**Application of David Kirk to rezone property from NS (Neighborhood Shopping) District to C-1 (Local Commercial) District to allow for development of a new drive-through restaurant, at 3795 North Druid Hills Road.**

**PETITION NO: D1. Z-21-1244885 (2021-2638)**

**STAFF ANALYSIS**

**Case No.:** Z-21-1244885 **Agenda #:** D1

SHEET NUMBER:  
**C-2.0**

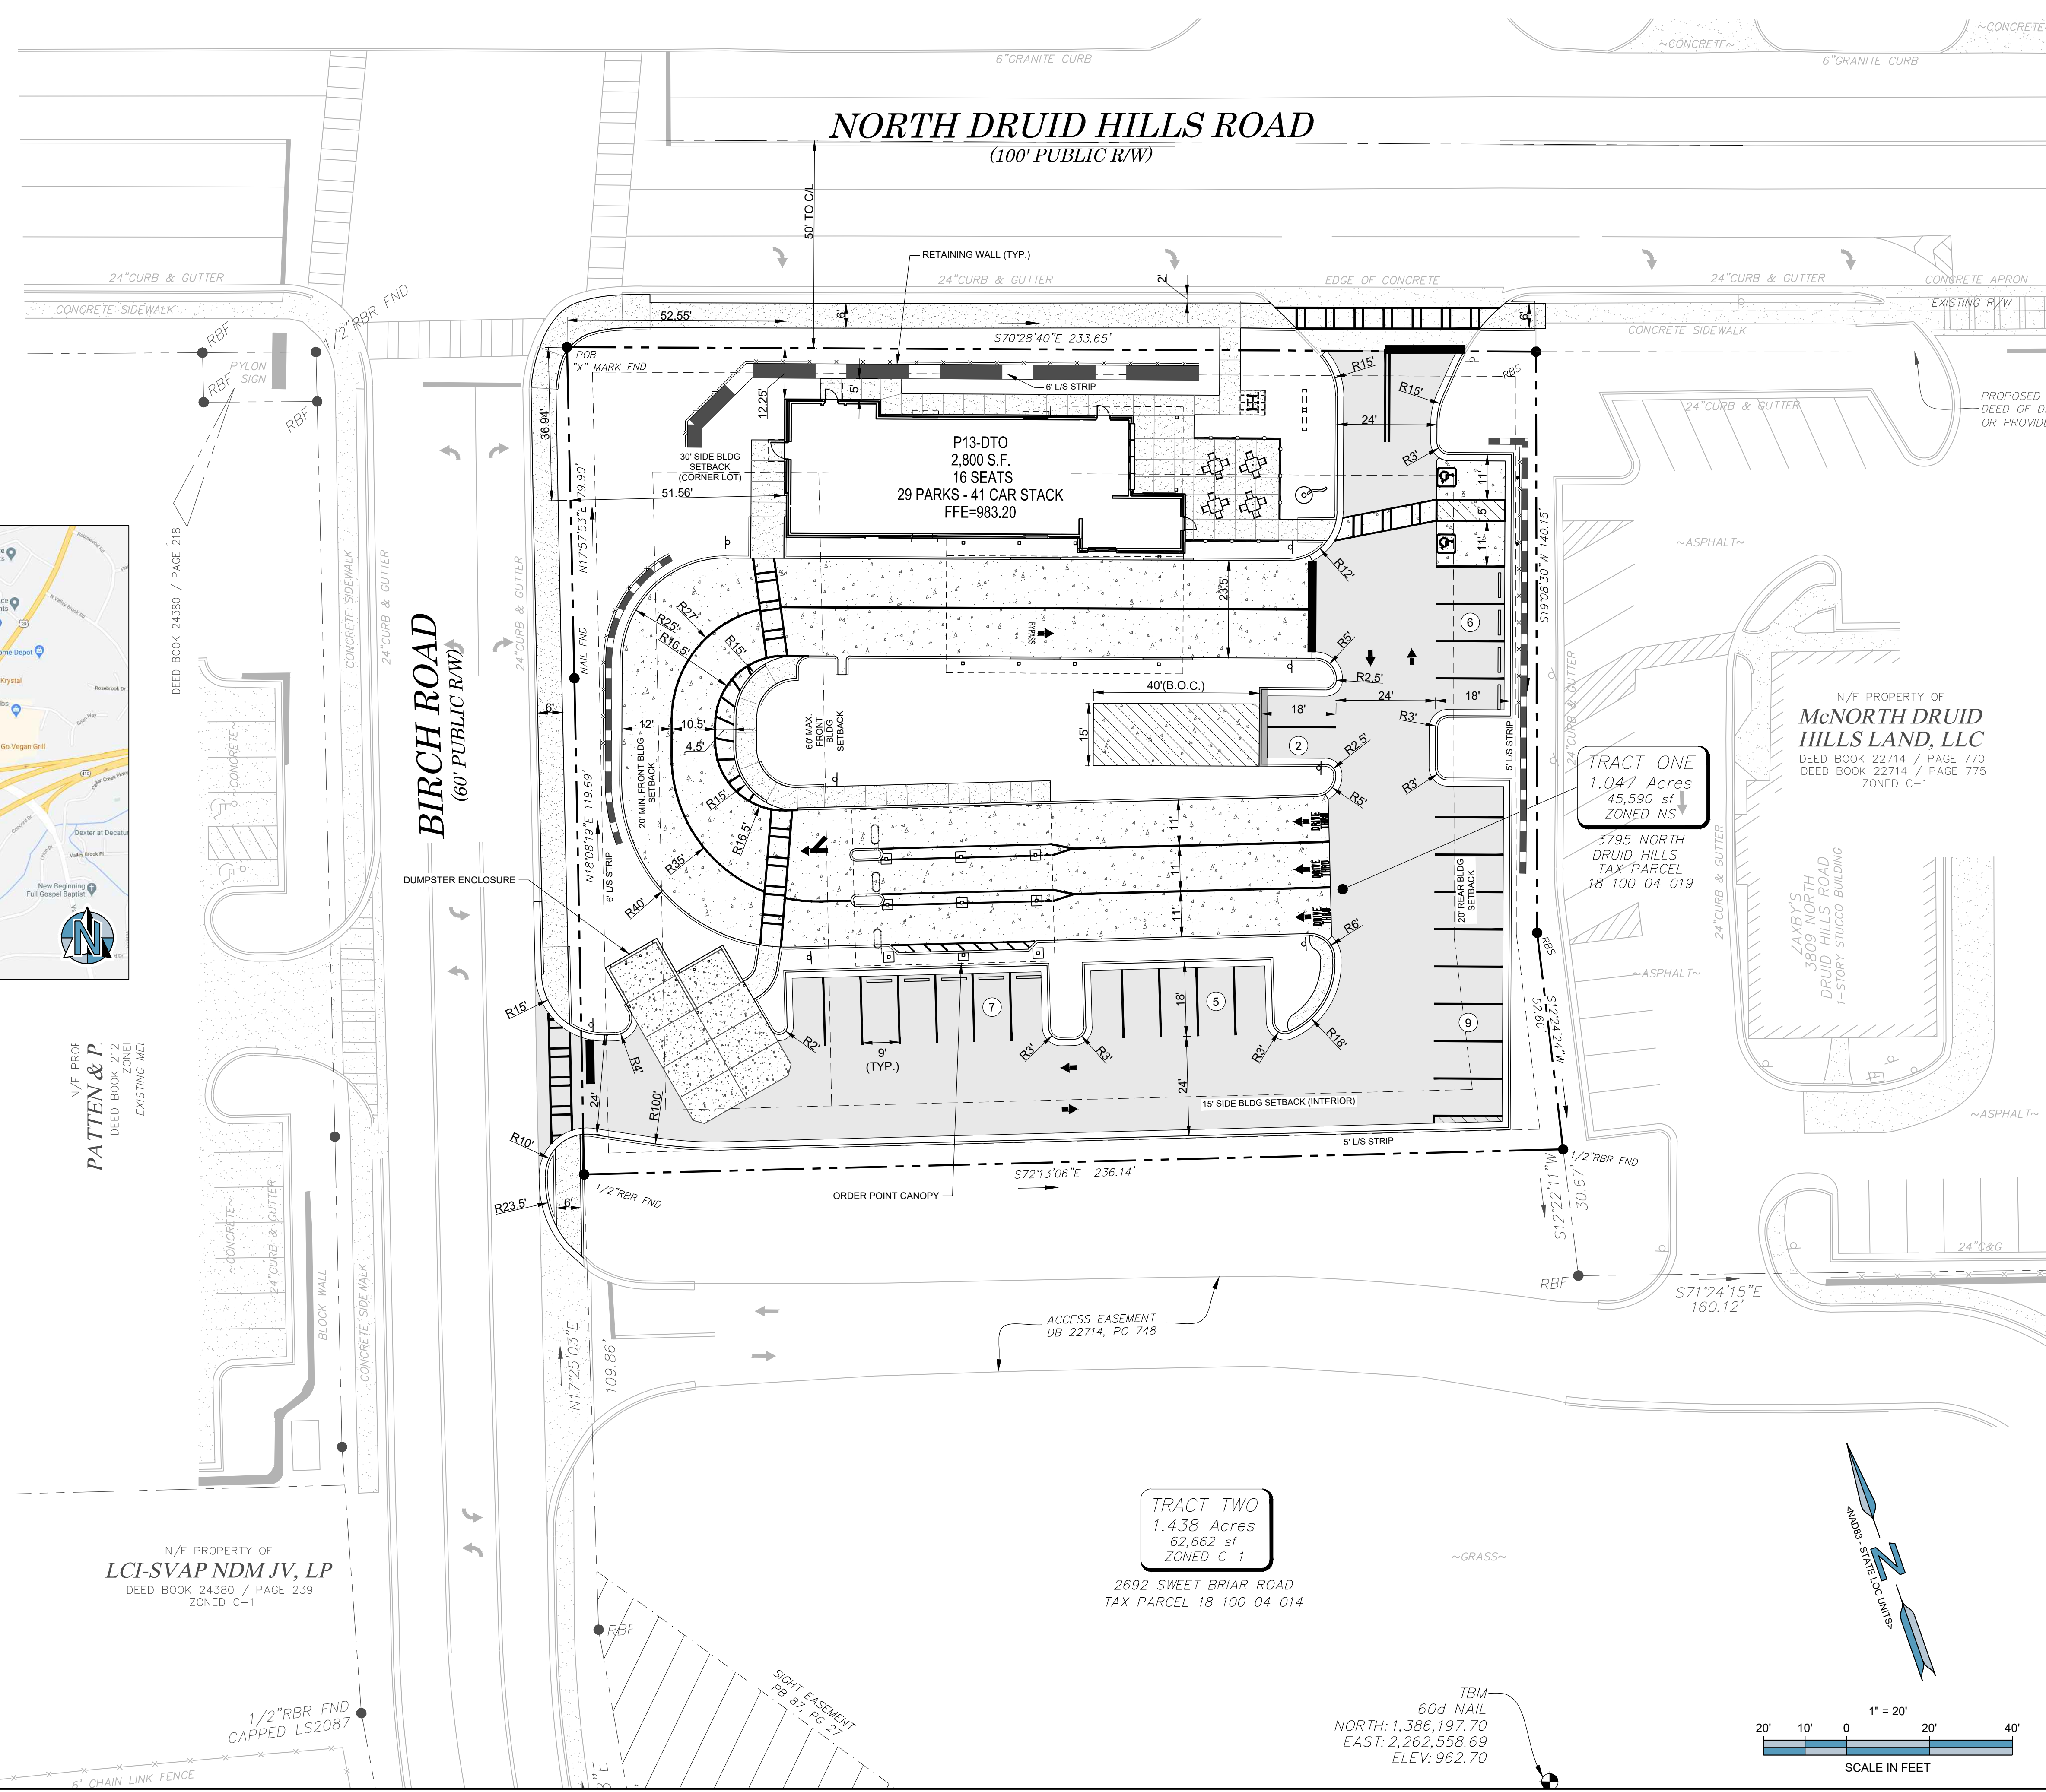
**N1 & N2 (Z-21-1244885 & SLUP-21-1244886)** - North Druid Hills is classified as a major arterial. Required to add a left turn lane onto Birch. Drive on North Druid Hills limited to Right in/right out only. Please see chapter 5 of the zoning code and chapter 14-190 of the land development code for infrastructure requirements. Requires 10 foot landscape strip, bike lanes and 6 foot sidewalks or 10 foot multiuse path (preferred), street lighting on back of sidewalk. Right of way dedication of 50 feet from centerline or such that all public infrastructure is within county right of way, whichever greater. Birch Road is classified as a local street. Requires a 27.5 foot right of way dedication from the centerline or such that all public infrastructure is on county right of way. Due to the proximity of the mall, potential for redevelopment and connectivity the residential areas- a 10 foot multiuse trail to be included in the sight design along Birch. Requires a 6 foot landscape strip. Streetlights required on back of path.
